CONSTRUCTION SUMMARY

Lindsay 2017 Developments Inc. / Sugarwood

Lot/Unit: 81    Phase/Building: 2    Model/Floor Plan: Rice Lake (4207) Elev B 4Bed 3.5Bath

SCHEDULE "B-1"  
Floor Plan

SKETCH #1

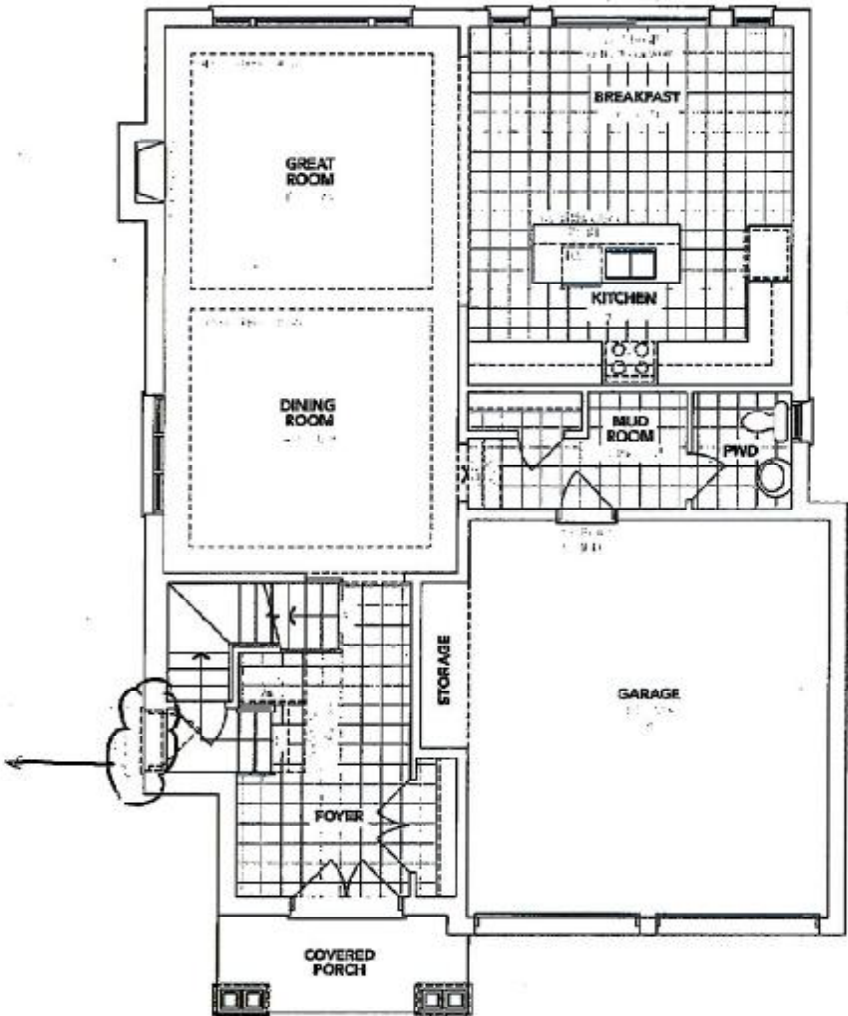
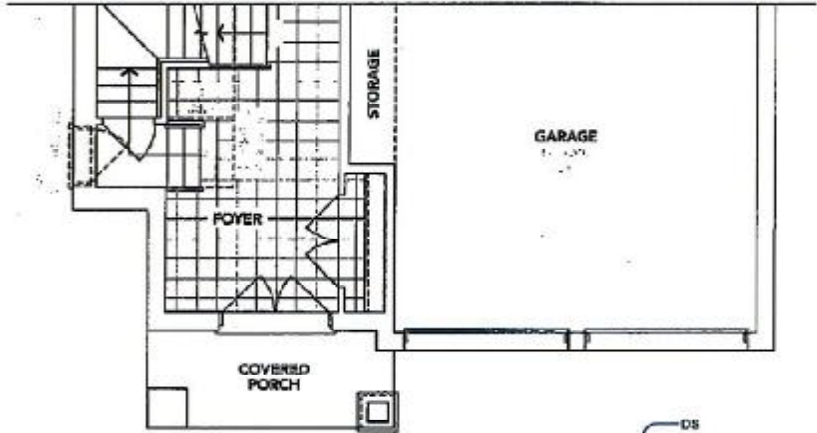
Inv.6276	1 - TO SUPPLY AND INSTALL THE OPTIONAL SIDE DOOR.. SEE SKETCH #1	
Line 79173	Note:	
2Jun23 / 12Jun23		
Inv.6276	5 - TO SUPPLY AND INSTALL THE UPG BASEMENT WINDOWS (SIZED 36X24") IN LIEU OF THE STANDARD.. SEE SKETCH #2	
Line 79175	Note:	
2Jun23 / 12Jun23

OPTIONAL SIDE DOOR
